Project Code & Schematics Subject: MS21 MP Main Board

FOXCONN		HON HAI Precision Ind. Co., Ltd. CCPBG - R&D Division
Title Index Page		
Size A3	Document Number (MS21-1-01)MainBoard (MBX-164) TYPE2	Rev 1.1
Date: Thursday, August 10, 2006	Sheet 1	of 78

MS20 MP to MS21 DVT Change History

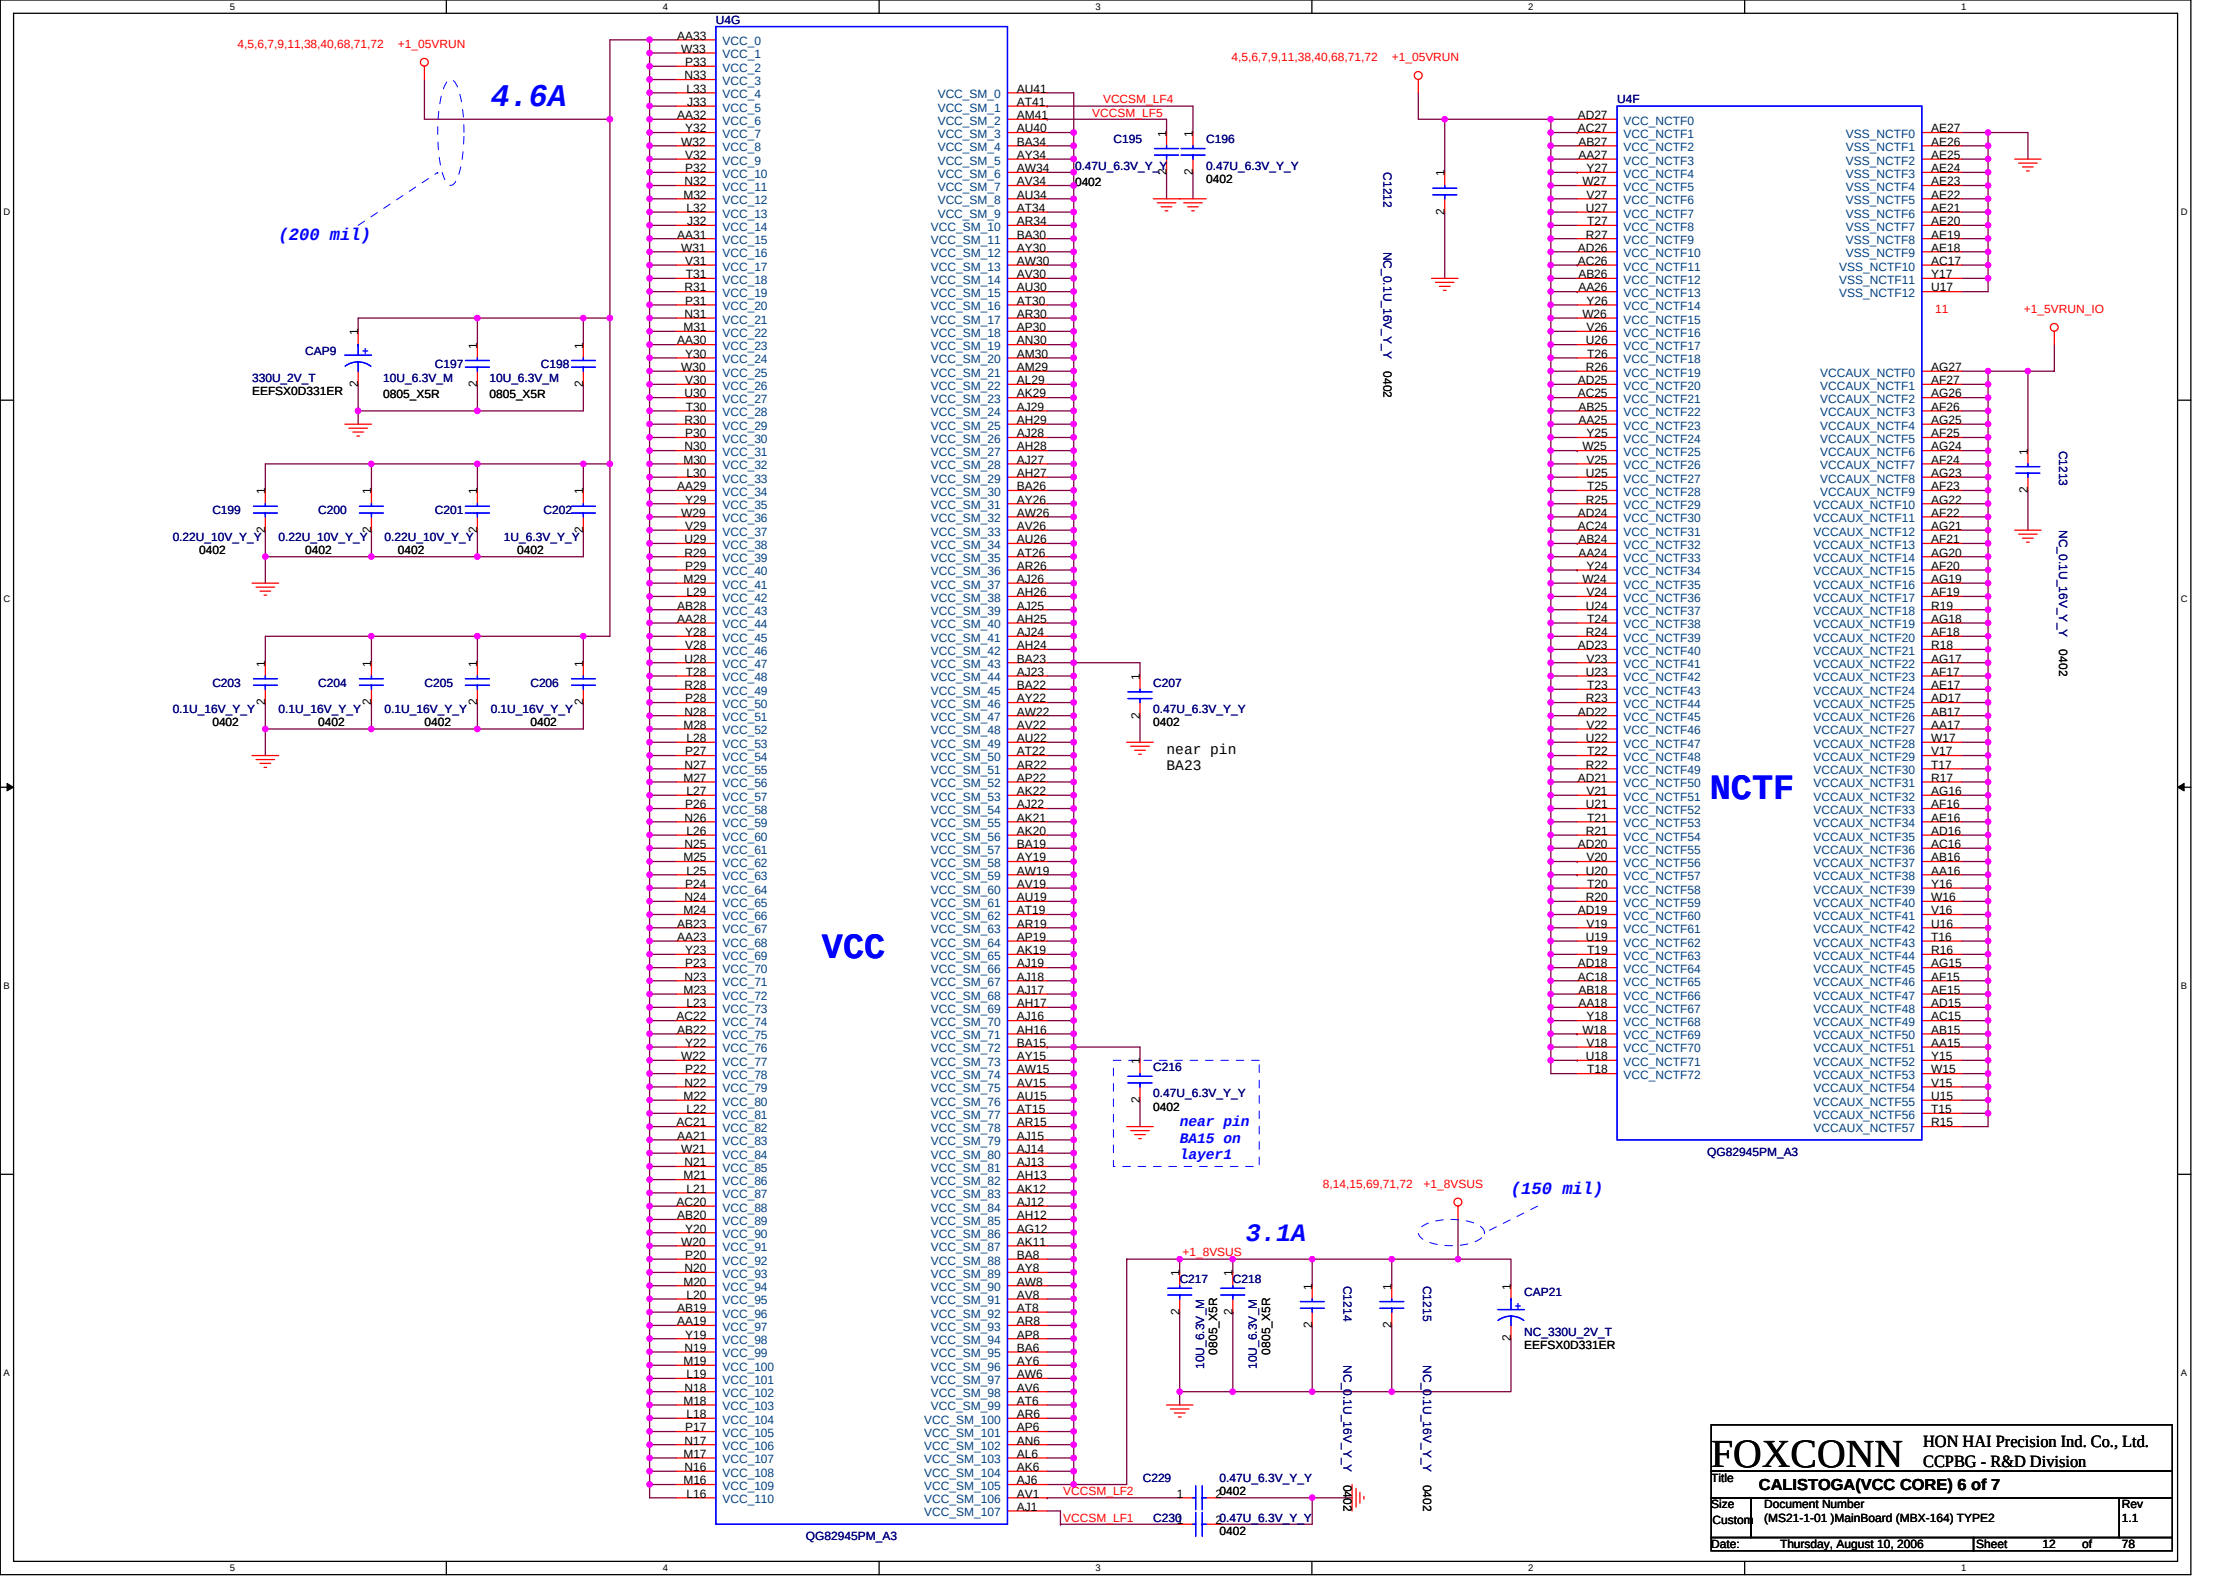
5/5 Remove R110 for PM_EXTTS#1 back up pull up res.
ICH7 (DPRSLPVR) already have internal pull up

FOXCONN		HON HAI Precision Ind. Co., Ltd.	
		CCPBG - R&D Division	
Title LVDS			
Size A3	Document Number (MS21-1-01) MainBoard (MBX-164) TYPE2		Rev 1.1
Date:	Thursday, August 10, 2006	Sheet	31 of 78

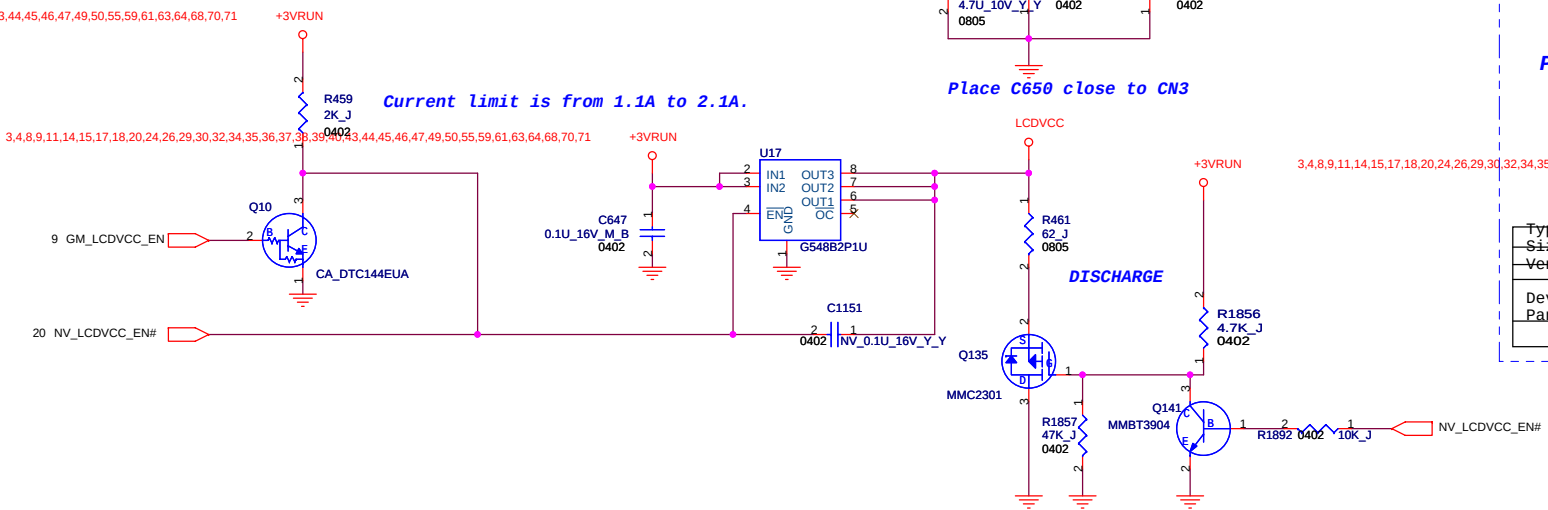
2006/6/26
(Del inverter boost circuit, after change, the inverter circuit is the same with MS20 MP)
Detail change list
Delete PR426&PR427 and change
C604-1, C1557-1, C1558-1, CN49pin1, pin2
net name INVERTER_VCC to net DCBATOUT.

Place C640 and C1558 close to CN49.

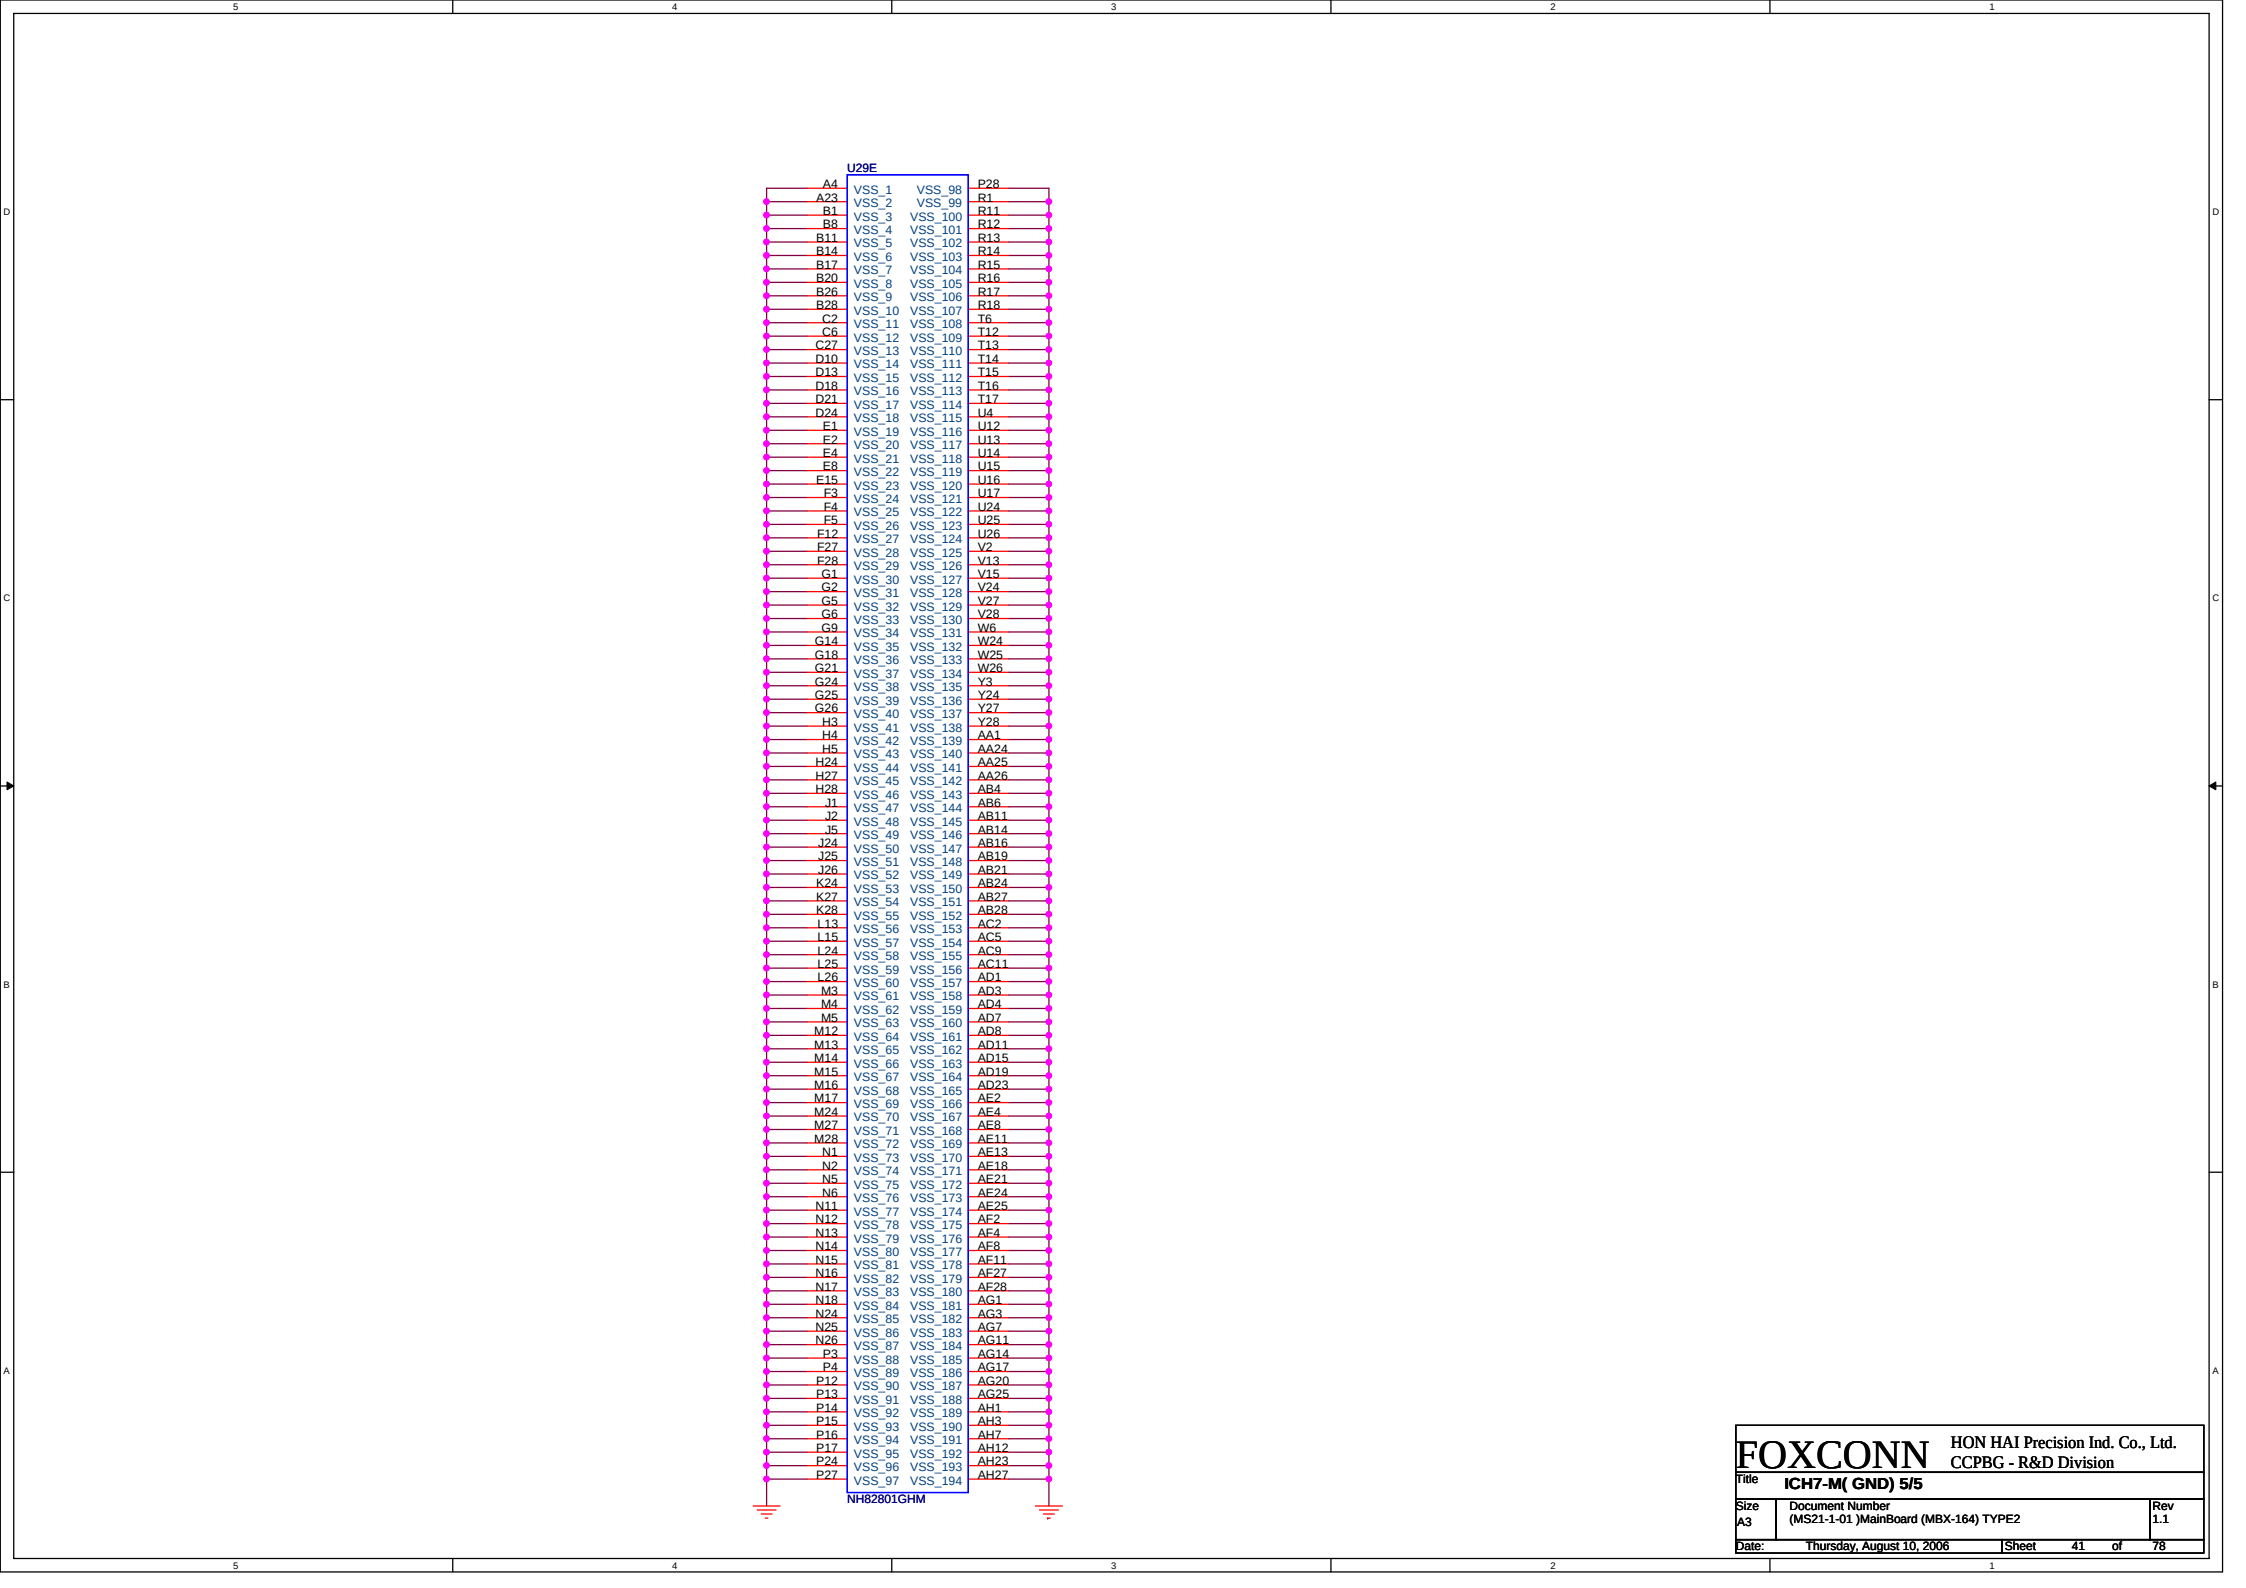
5/6
 For power droup cause 0.16V voltage loss Issue
 (1)F7,F8,F19,F20 no stuff
 (2)Co-layout normal open gap GP17~GP18 with fuse
 5/27 Delete SATA HDD Fuse backup circuit
 (1)Remove F7,F8,F19,F20 Pad
 (2)Remove GP17~GP18 open gap

INTERNAL SPEAKER

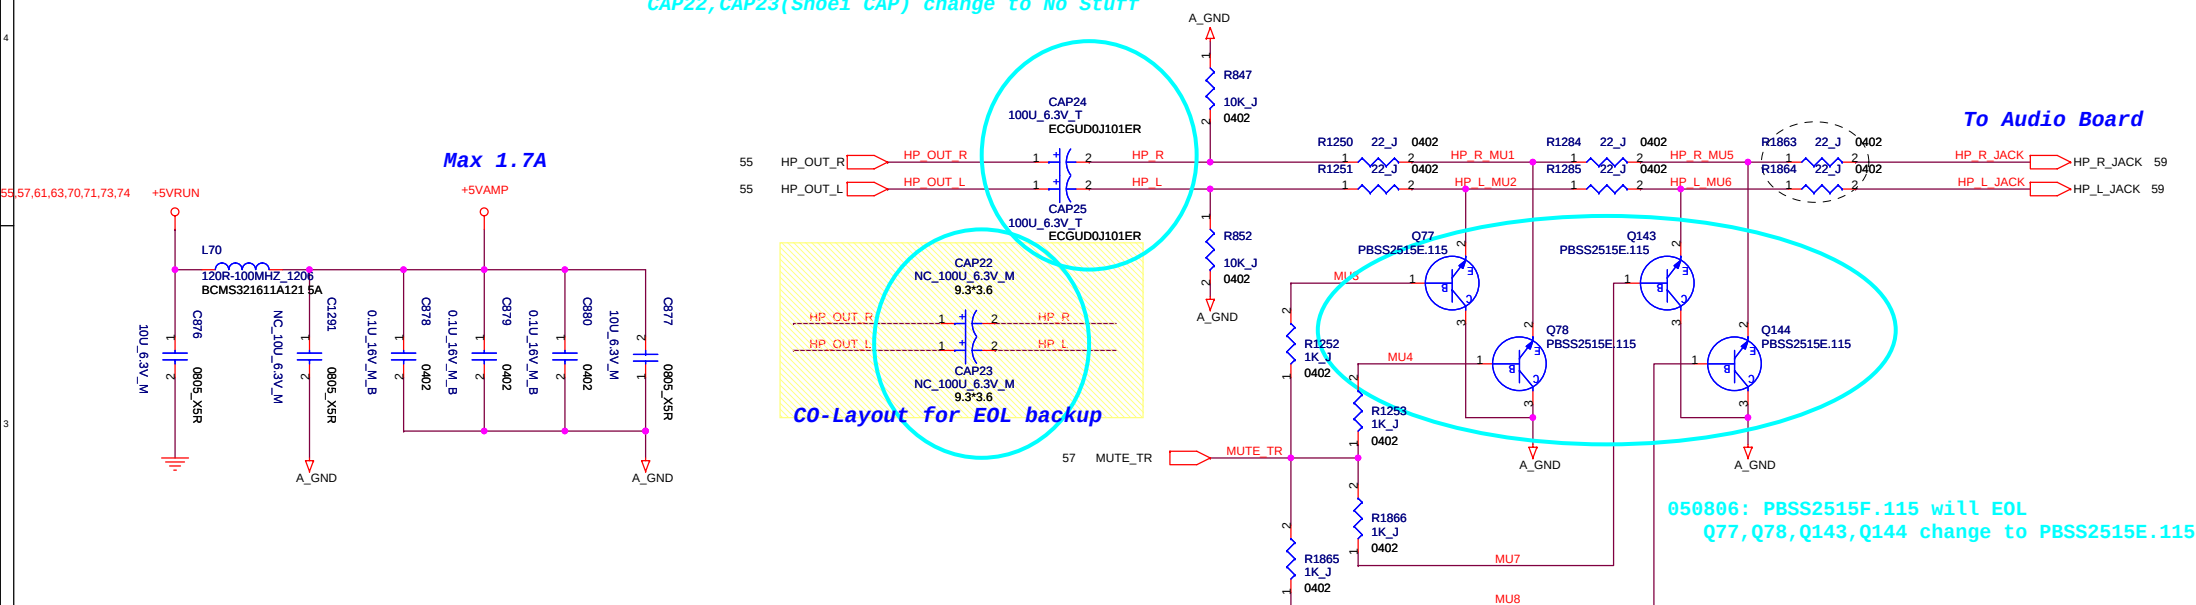
```
050806: Shoei CAP will EOL
CAP24,CAP25(SP CAP) change to Stuff
CAP22,CAP23(Shoei CAP) change to No Stuff
```

050806:(Improve the voice of speaker up to 0.94W).
Add damping Resistors R1953 on AMP_SRIN, R1954 on AMP_SLIN
then speaker amp output won't be distorted.
For speaker loudness issue.

2006/6/26
Modify internal speaker AMP gain setting, change R1953/R1954 from 4.7K (AMP output 1.12W) to 5.1Kohm (AMP output 0.98W) to fit in speaker (1.0W) spec.

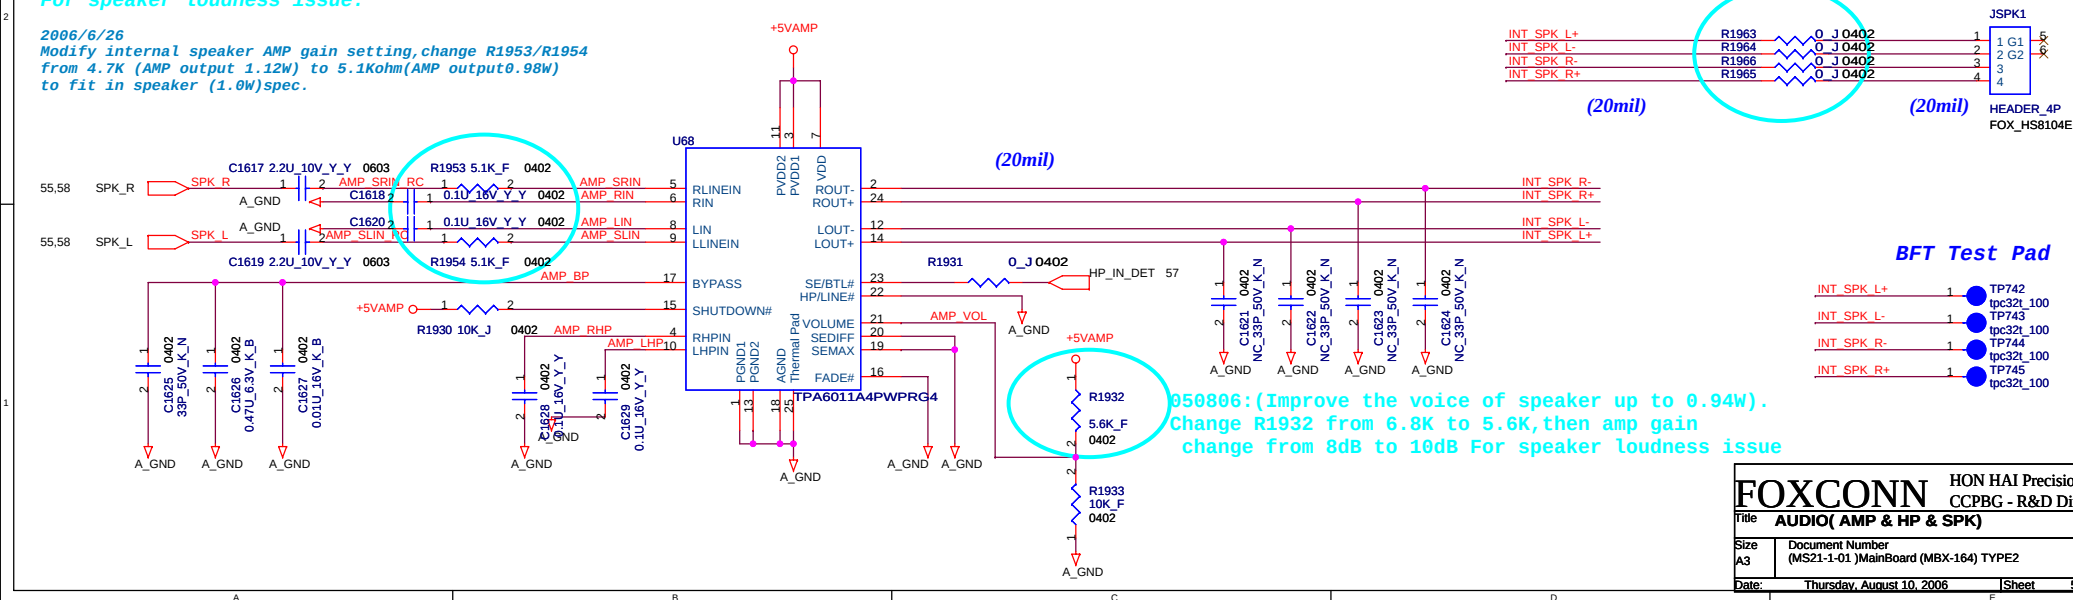
```
050806:(Improve the voice of speaker up to 0.94W).
EMI team confirm whether
it is ok to use 0ohm resistor replacing bead
```

050806:(Improve the voice of speaker up to 0.94W).
Change R1932 from 6.8K to 5.6K,then amp gain
change from 8dB to 10dB For speaker loudness issue
